Evaluation of proposed move for Water Right No 1589

Proposed: Move water right no. 1589 a distance of 474 ft to the southwest.

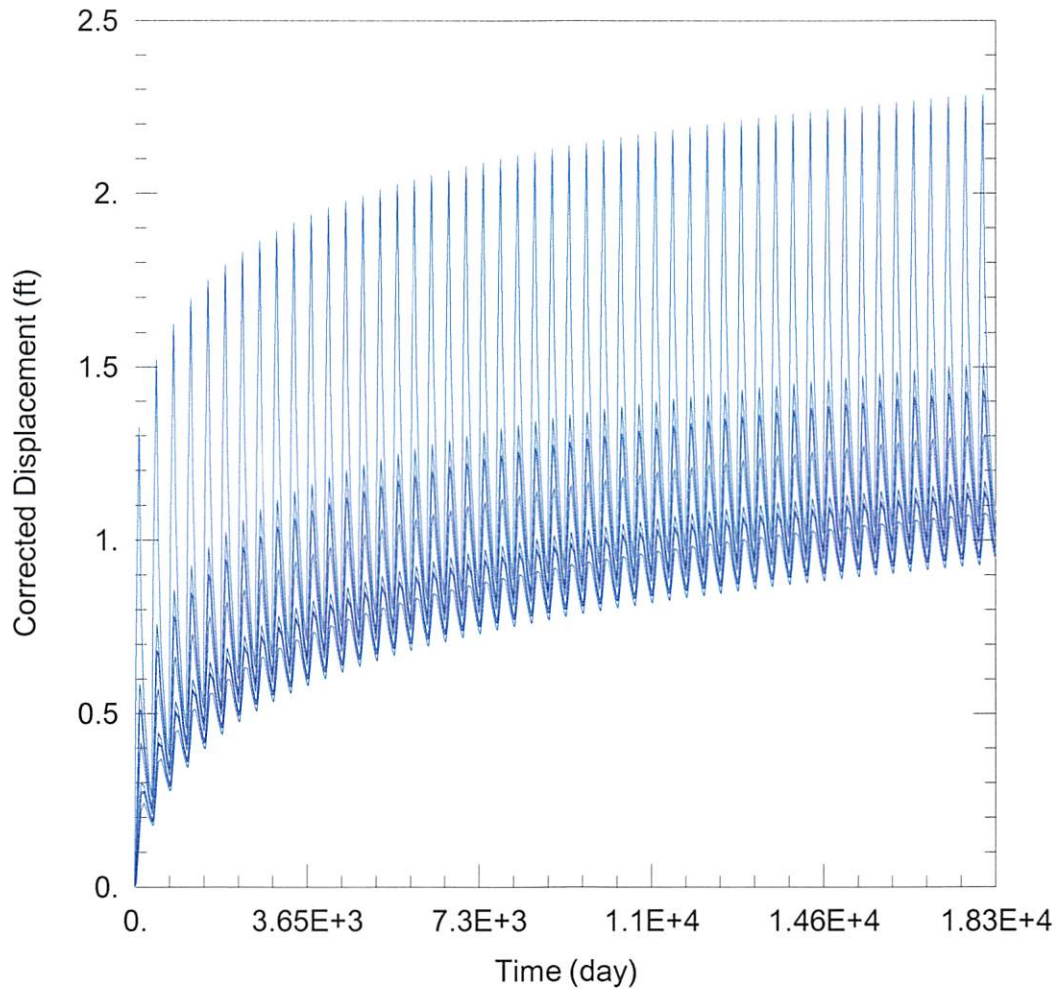
Wells within 1 mile: 11658, 11699, 30595, 21481, 11960, and 3 domestic wells, numbered on the above map.

11658: Drawdown from current location = 2.29 ft
Drawdown from proposed location = 4.57 ft
Net drawdown = **2.3 ft**

11699: Drawdown from current location = 1.43 ft
Drawdown from proposed location = 2.60 ft
Net drawdown = **1.2 ft**

30595: Drawdown from current location = 1.08 ft
Drawdown from proposed location = 2.03 ft
Net drawdown = **1.0 ft**

21481: Drawdown from current location = 1.17 ft
Drawdown from proposed location = 2.29 ft
Net drawdown = **1.1 ft**

11960: Drawdown from current location = 1.31 ft
Drawdown from proposed location = 2.33 ft
Net drawdown = **1.0 ft**

Domestic 1: Drawdown from current location = 1.51 ft
Drawdown from proposed location = 3.13 ft
Net drawdown = **1.6 ft**

Domestic 2: Drawdown from current location = 1.14 ft
Drawdown from proposed location = 2.02 ft
Net drawdown = **0.9 ft**

Domestic 3: Drawdown from current location = 1.13 ft
Drawdown from proposed location = 2.02 ft
Net drawdown = **0.9 ft**

Net drawdown does not exceed the drawdown allowance of 3.5 ft for any wells within 1 mile of the proposed location. Therefore, critical well analysis is not necessary.

Based upon information from the GMD3 model, this proposal will cause minimal effects on neighboring wells, and is unlikely to create an impairment. GMD3 staff recommends approval of the application.
